Recall Service Bulletin RSB21-330-004A

This Recall service bulletin applies to 2016 through 2021 model year, **APPLIES TO:**

Solenoids may be subject to internal corrosion. **CONDITION:**

Remove and replace solenoids with those that are appropriately rated for **CORRECTION:**

Figure 3.1

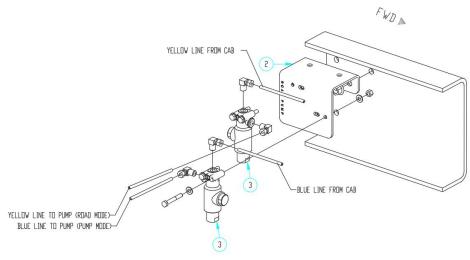
- 5. Remove mounting bracket with solenoids from the chassis.
- 6. Remove solenoids from the mounting bracket.
- 7. Assemble solenoid valve assembly using solenoid part number 0918-MM5-012. Install 90° fittings part number 3092-MM5-A02 to the solenoids. Mount solenoids to the bracket part number 5034-MM5-001. Reference Figure 3.1
